Attachment 1 - Section 92 Request for Information: BUN60422958		
Item	Council Information Request	Applicant's response
Transport		
TRA1	Please provide further detail on the parameters used/assumptions made on the stop-go operation on SIDRA and the phasing summary of the SIDRA outputs.	Attachment 2 provides the phasing summaries for the NORMAL and CHRISTMAS scenarios for the stop-go operation. We allowed for a maximum of 150secs for the 'Practical Cycle Time' setting to run the model. A yellow time setting of 2 seconds and all-red time setting of 15 seconds was input based on the length of the stop-go operation.
TRA 2	Please provide further detail on the duration of construction works if an open trenching construction method is used for the pipeline underneath Brigham Creek Road.	Installing the pipeline underneath Brigham Creek Road is anticipated to take approximately 2 weeks, including 1 week to install the pipeline, and 1 week to resurface and reinstate the carriageway. It is noted that the final road resurfacing and reinstatement works are dependent on weather conditions. In the event of poor weather, additional time may be required. As shown by the modelling, works of approxima

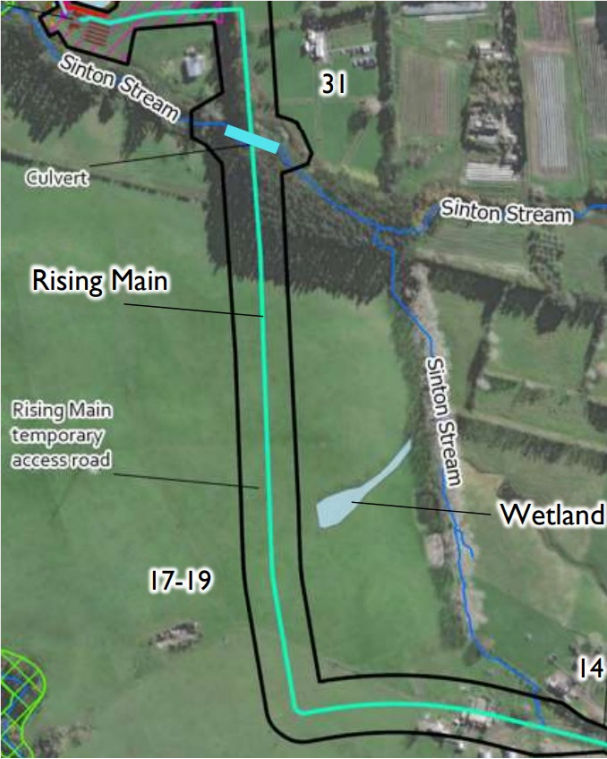
TRA 5	Please demonstrate vehicle manoeuvring through the rising main temporary access road using a truck and trailer.	Please note that the aqua line on Figure 5 below is the location of the rising main, rather than the access road. The rising main access road will be located predominantly within the designation. If manoeuvring of the 23m truck and trailer cannot be achieved within the boundary of the designation at the northern and southern ends, the access road may track outside the designation for a minimal section.  Figure 5: Rising main
TRA 6	Please outline how vehicle access into SAP 4 from Tamiro Road can be provided, while avoiding the stormwater pond and road infrastructure such as light poles. Please demonstrate a truck can enter and exit through this access in a forward direction.	Traffic assessment on SAP 4 was based on the assumption that it will not be using the existing vehicle crossing that accesses an existing maintenance facility. Other key assumptions at the time was that a new vehicle crossing would be constructed adjacent to the existing one and a corresponding internal vehicle path constructed also. Details of this internal vehicle path was assumed to have flexibility to be accommodated to suit within the property and therefore internal tracking was not carried out at the time of the assessment – we were advised at the time that a vehicle would have sufficient space to turn around and exit in a forward direction. The vehicle tracking into the actual site (SAP4) was therefore mainly to validate that a right turn into the site was feasible with final confirmation of location to be determined. That said, location 1 as shown in Figure 6 below has the light pole and planting that would likely be affected at that specific location. Another potential location marked '2' in Figure 7 below would be able to replicate the same tracking parameters.
